DeKalb County Historic Preservation Commission

Staff Report

I. 1449 Cornell Road, Jesse and Danielle Kaba. Enclose a covered porch on the front of a historic house. **1248162.**

Front view:

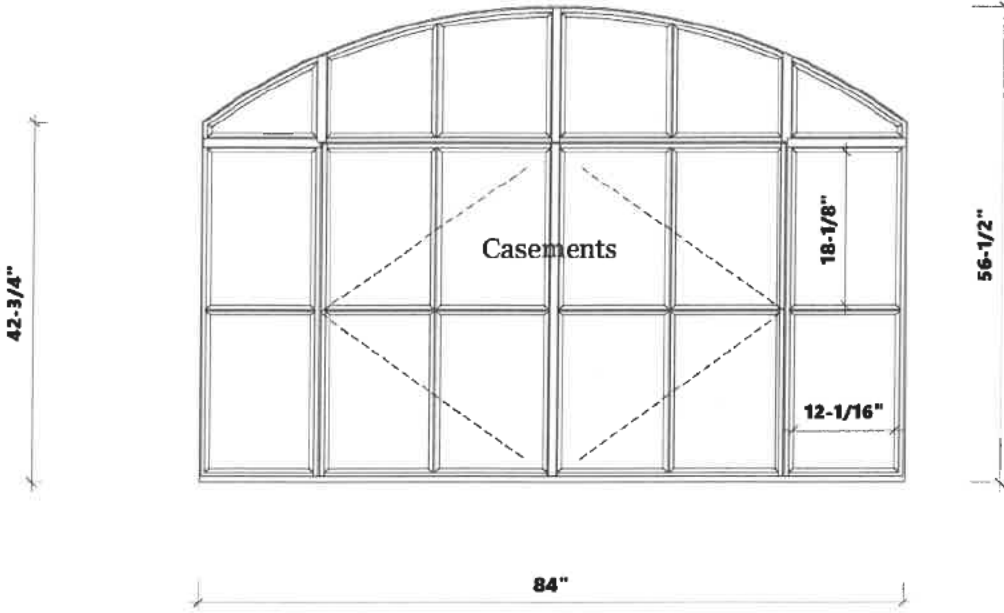
The applicant proposes enclosing an existing screened front porch. The porch will be enclosed by replacing the existing screens with glass windows, both on the front and side of the house. The existing screen enclosures will not be modified, but the screens and wood framing will be removed and replaced with windows. The windows that will be placed in the openings of the covered porch will be arched, transom casement windows with divided panes.

Approve. These proposed changes do not appear to have a substantial adverse effect on the district. This application appears to meet the guidelines and the staff recommends approval.
